Service Bulletin

Bulletin No.: PIP5059

Subject: Whistle Or Whine Noise In 3rd Gear May Be More Pronounced On A Coast

Models: 2010 - 2013 Chevrolet Colorado, Express, Silverado
2010 - 2013 GMC Canyon, Savana, Sierra
Equipped with 4L60E (M30) Automatic Transmission

2907599

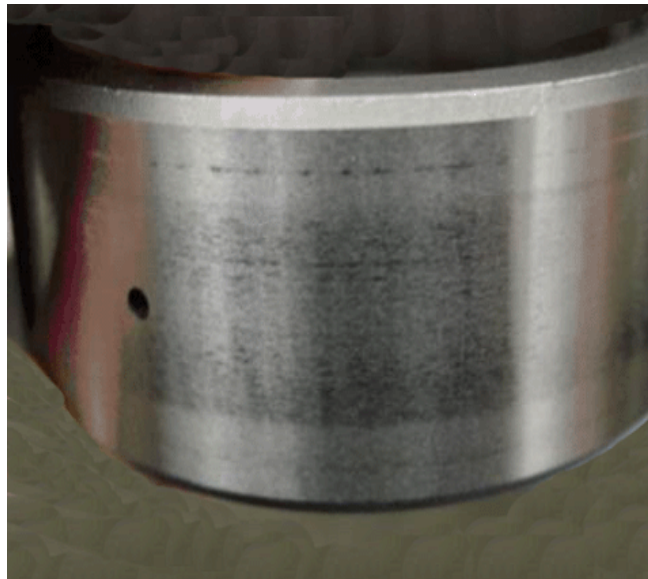
This condition may be caused by machining marks on the low roller clutch inner race (675).

Inspect the race (675) for machining marks or damage to the race area and replaced it as necessary.
